Minor Change to the On-Post Record of Decision for RCRA-Equivalent Soil Covers, Rocky Mountain Arsenal

Fact Sheet

April 26, 2007

Figure 2 Cross Section of RMA RCRA-Equivalent Cover

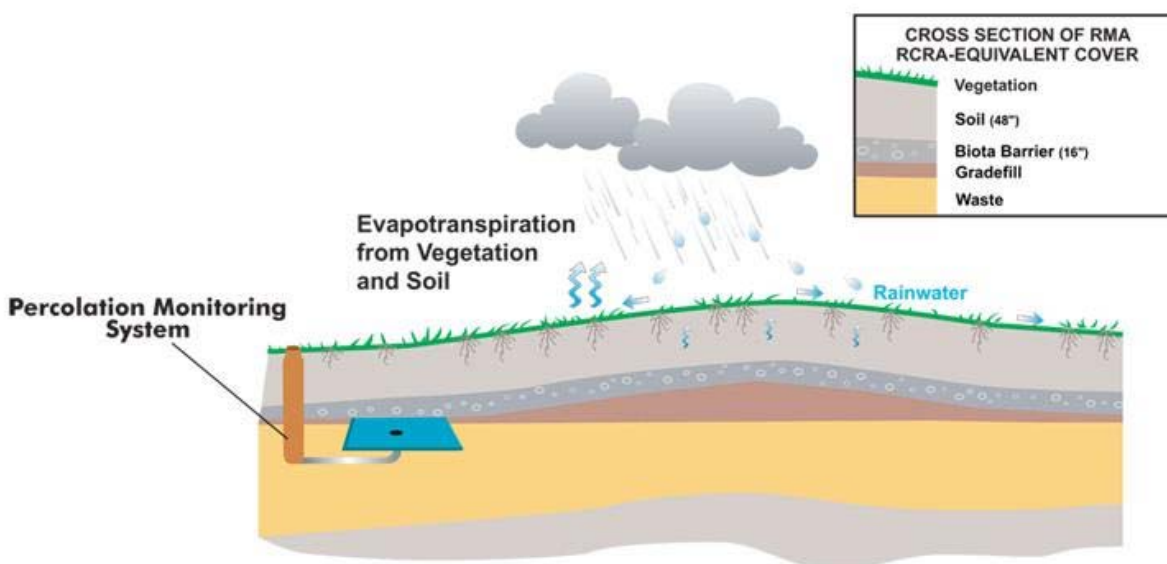
The change from non-RCRA-equivalent to RCRA-equivalent covers requires several changes to the projects. The primary change is the compliance standard for percolation of water through the covers. The RMA's RCRA-Equivalent Cover Demonstration Project established a performance standard for percolation of no more than 1.3 mm/year (RVO 1998). In order to provide cover compliance monitoring, cover construction will include a measurement tool (percolation monitoring pans known as lysimeters) to measure water percolation below the soil covers.

The change to RCRA-equivalent covers also requires the application of more stringent soil type requirements for construction. Following the completion of the RCRA-Equivalent Cover Demonstration Project field demonstration, an evaluation was conducted to establish design criteria for the full-scale RCRA-equivalent cover implementation projects. An assessment of the test cover soils used in the field demonstration and further evaluation of soil properties were conducted to ensure that the full-scale cover soil material and placement specifications would result in cover performance equal to or better than that achieved in the field demonstration. As a result, specific criteria for soil textures were created (TtFW 2005c). Construction of RCRA-equivalent covers will use these criteria in selecting the appropriate soils for the covers.

During the RCRA-Equivalent Cover Demonstration Project, it was determined that during relatively wet weather periods, an additional impediment to percolation, referred to as a capillary break, was forming at the bottom of the test covers due to the contrast in pore size between the finer-grained cover soils and the underlying geotextile (a coarser material) that was placed as part of a geocomposite drainage system to collect and measure percolation. Further data review from the demonstration project led to the conclusion that the combination of the cover soils and the capillary break in the test covers was sufficient to meet the 1.3 mm/year percolation standard. Consistent with subsequent laboratory testing, the capillary break design selected for use in the RCRA-equivalent covers incorporates a geotextile between the fine-grained cover soil and the coarse wildlife barrier surface to enhance the performance of the capillary break (TtFW 2005b).

The high visibility warning tape recommended during the Basin A design was eliminated in favor of high visibility (orange) geotextile. The geotextile, added to enhance the performance of the capillary break, provides a subsurface warning to humans and eliminates the need for the warning tape layer within the cover soil. Also, during design, a concern was identified for geotextile placement directly over the crushed concrete barrier. Therefore a bedding soil layer overlying the wildlife barrier was added to the cover design. The bedding soil will fill voids in the surface of the crushed concrete barrier layer and provide a relatively smooth surface for placement of the geotextile.

Consistent with final design discussions, cover projects with an assumed 12-inch-thick wildlife barrier in the ROD have been modified to include the 16-inch-thick barrier with the 50-foot minimum extension. This includes the South Plants CPA and Former Basin F, as well as the cover designs for the on-site landfills and the Section 36 Lime Basins. In the case of the Lime Basins, a ROD Amendment completed in 2005 (TtEC 2005) changed the remedy for the Lime Basins to include a RCRA-equivalent cover. The ROD Amendment specified an 18-inch-thick wildlife barrier consistent with the Basin A recommendations. The ICSD, which includes the Lime Basins cover construction, modifies the barrier thickness to be consistent with the final barrier thickness criteria.
